# Amesbury School Building Committee November 19, 2020

# Amesbury Elementary School

# Project Updates

# Entry Drive Design | Peer Review Update

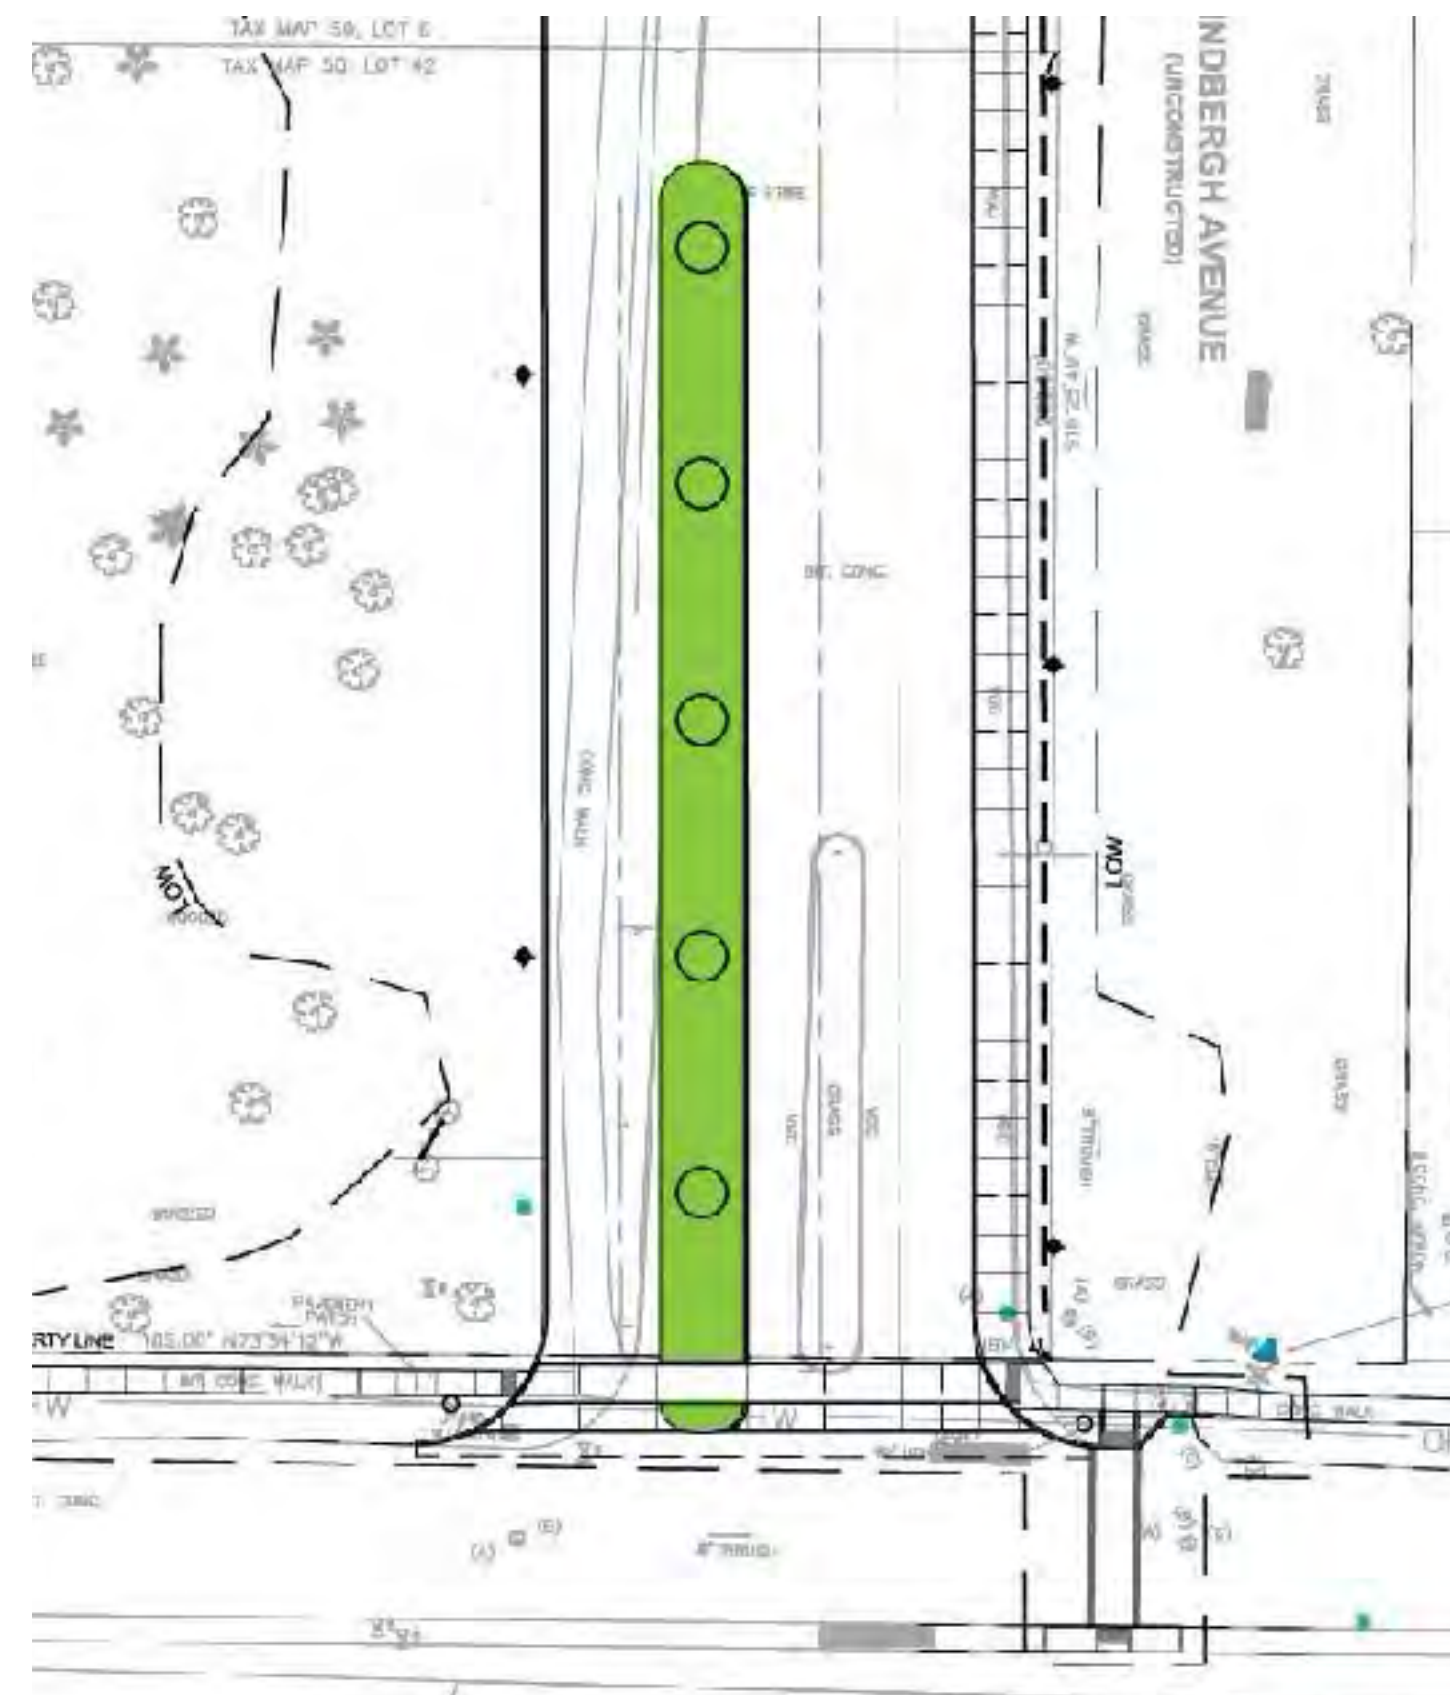
Proposed:

2 lanes for exiting - 23' wide

Revised:

1 lane for exiting - 20' wide  
(to accommodate emergency vehicles)

# Proposed | Site Lighting Photometrics

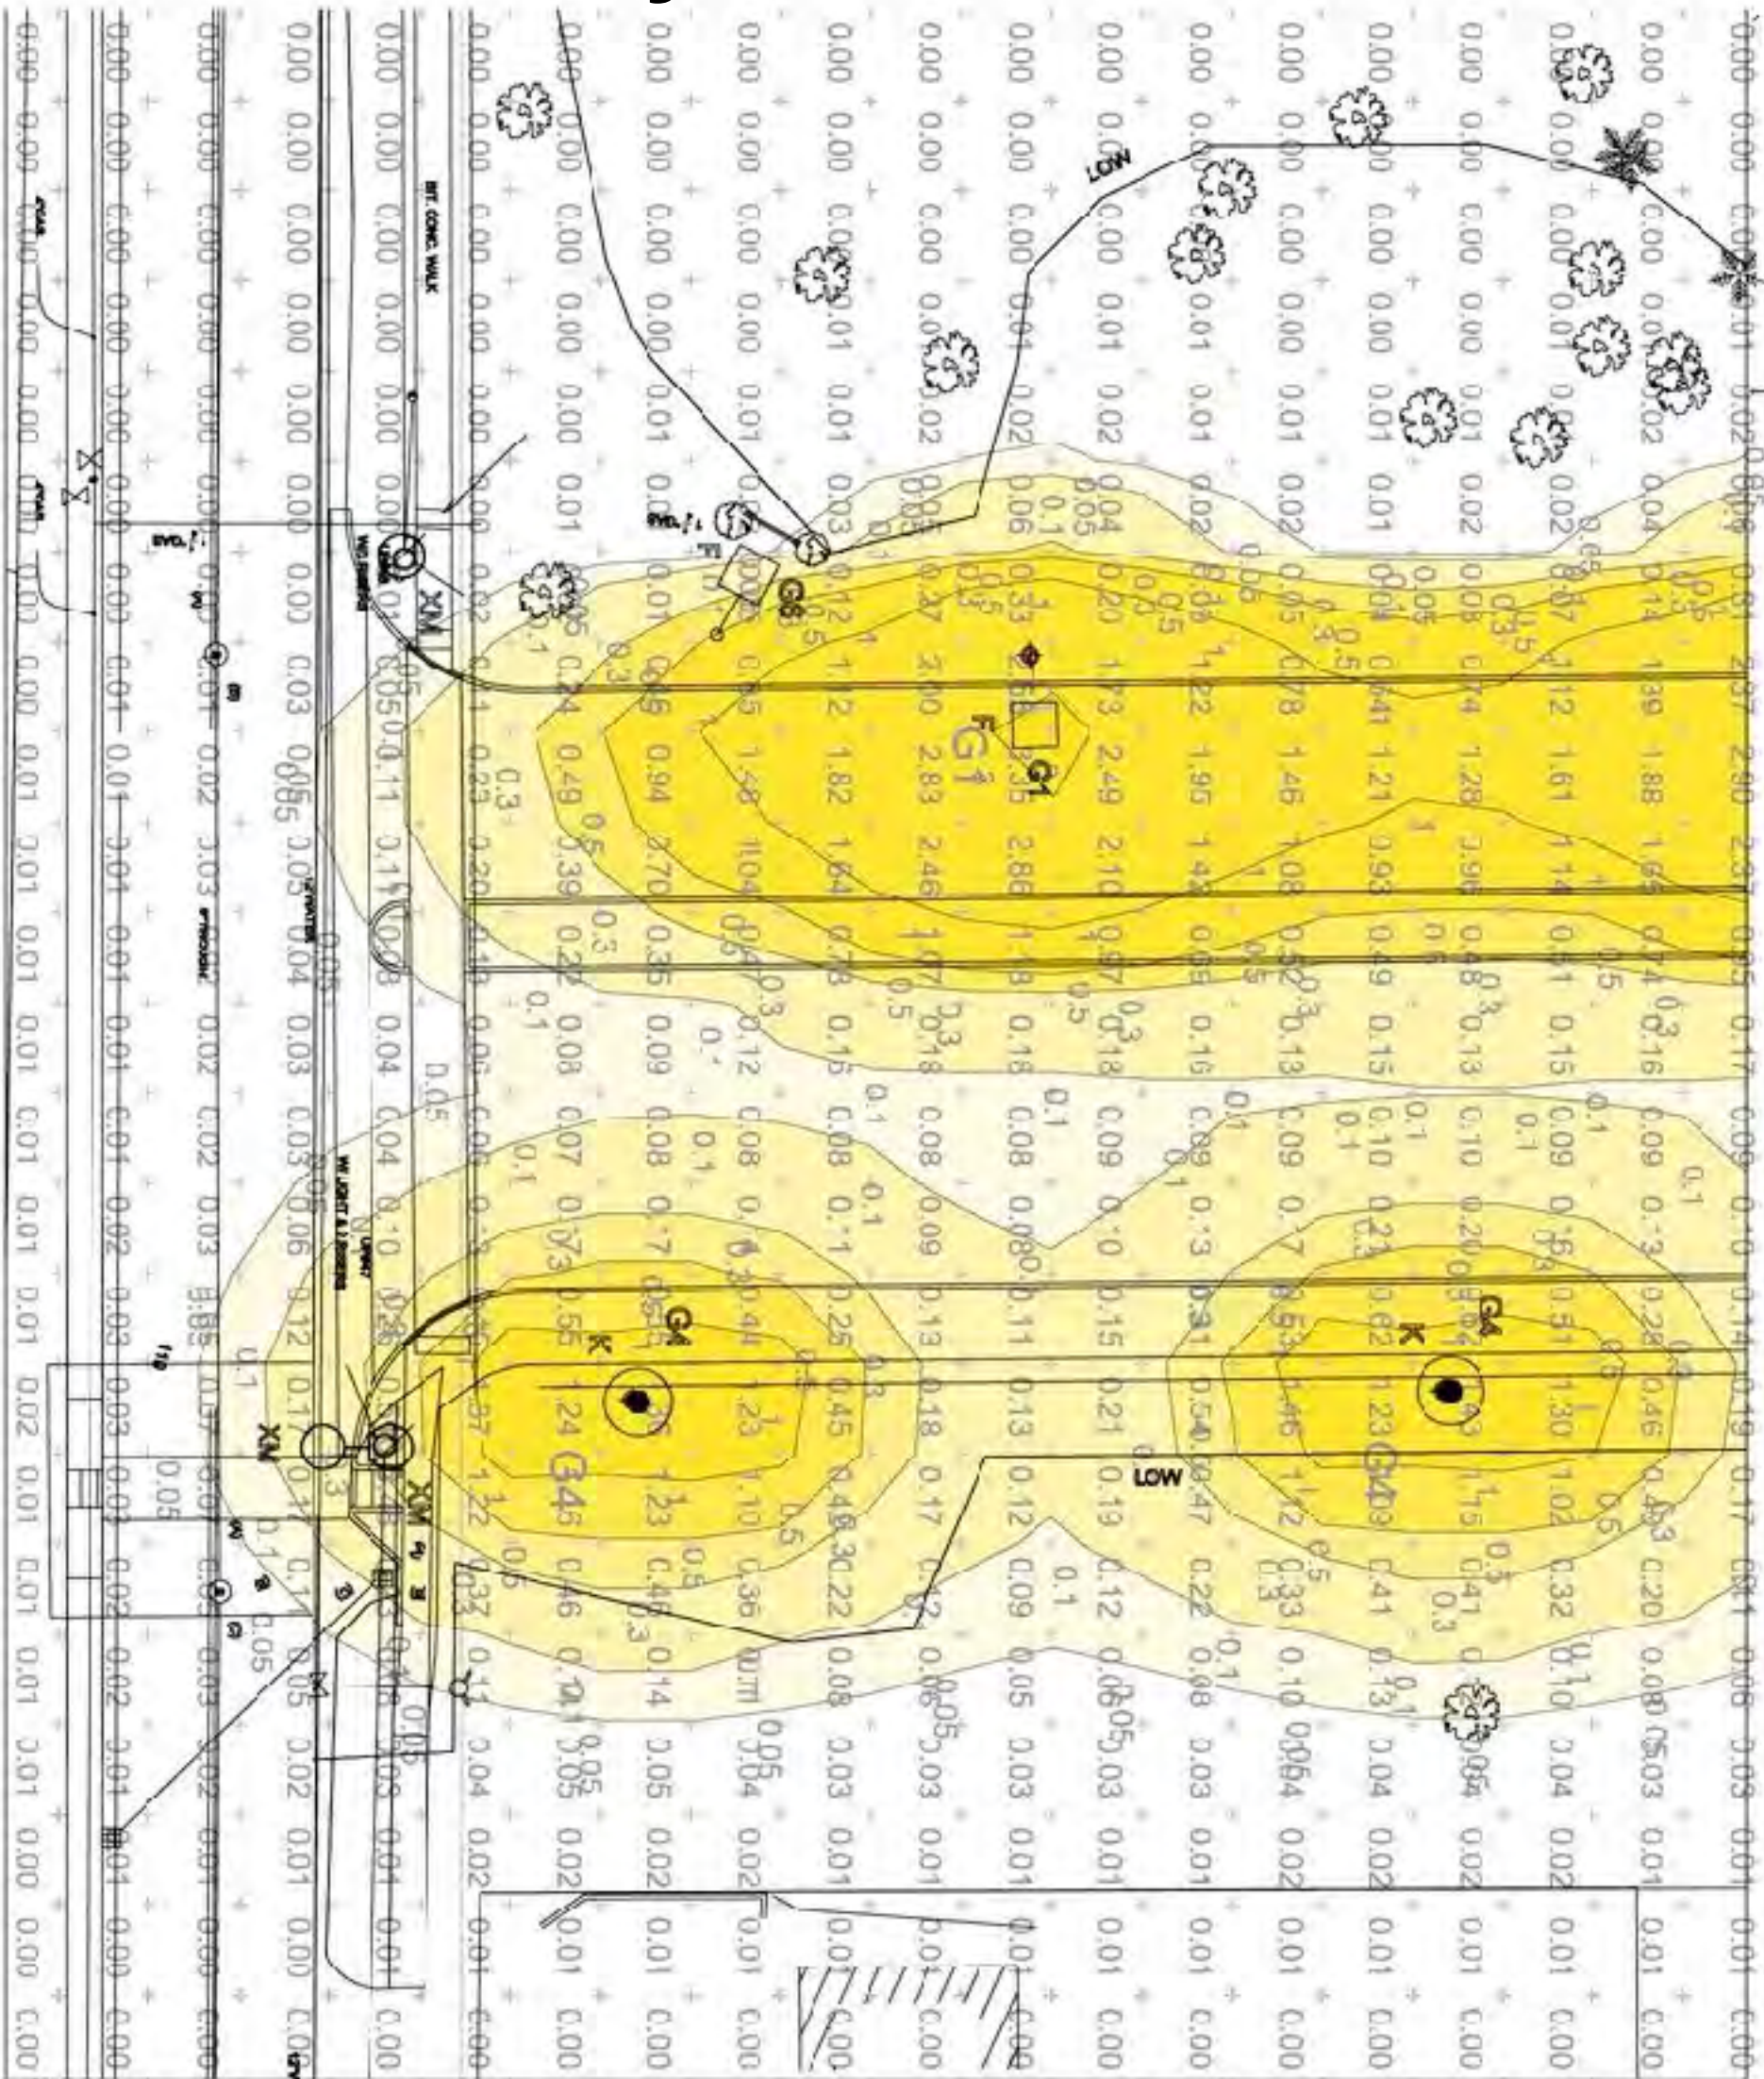
Exterior lighting controls and programming  
to be provided for Peer Review responses
